17 May 2024

Our reference: 213843

RE: State Significant Development Application SSD-30628110 ‘Summit at Kemps Creek’ at 706-752 Mamre Road, Kemps Creek

Figure 1. Wastewater catchments

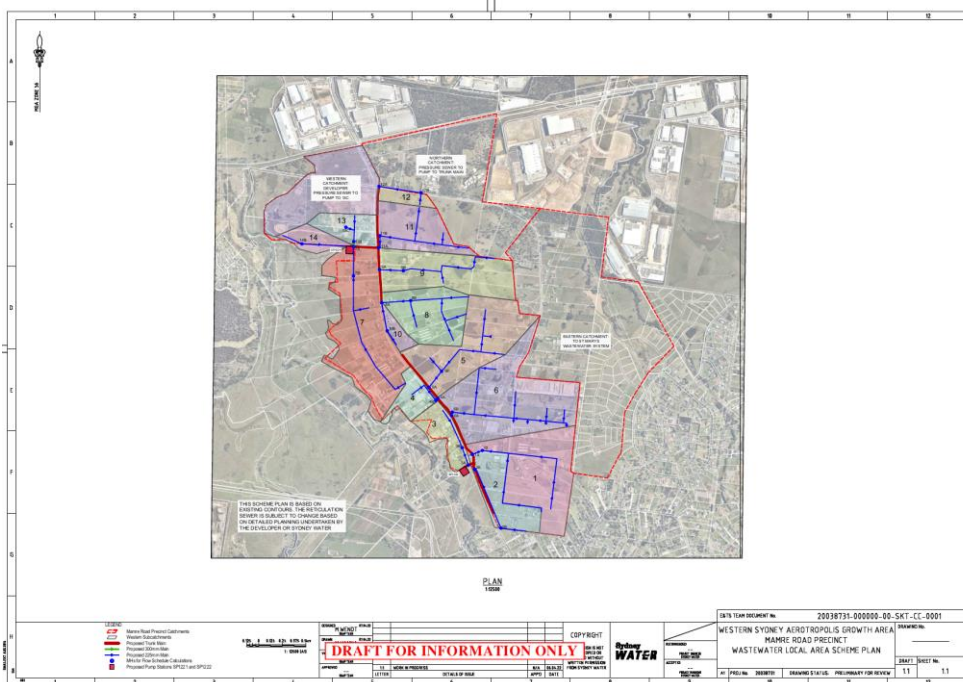
Sydney Water identifies that the proposed development is within two wastewater catchments. The western part of this proposed development is within the proposed wastewater pumping station SP1221 catchment via proposed trunk wastewater carriers. The eastern part of the development is located within the existing St Marys system. Please refer to Figure 1 regarding the wastewater catchments of the site.
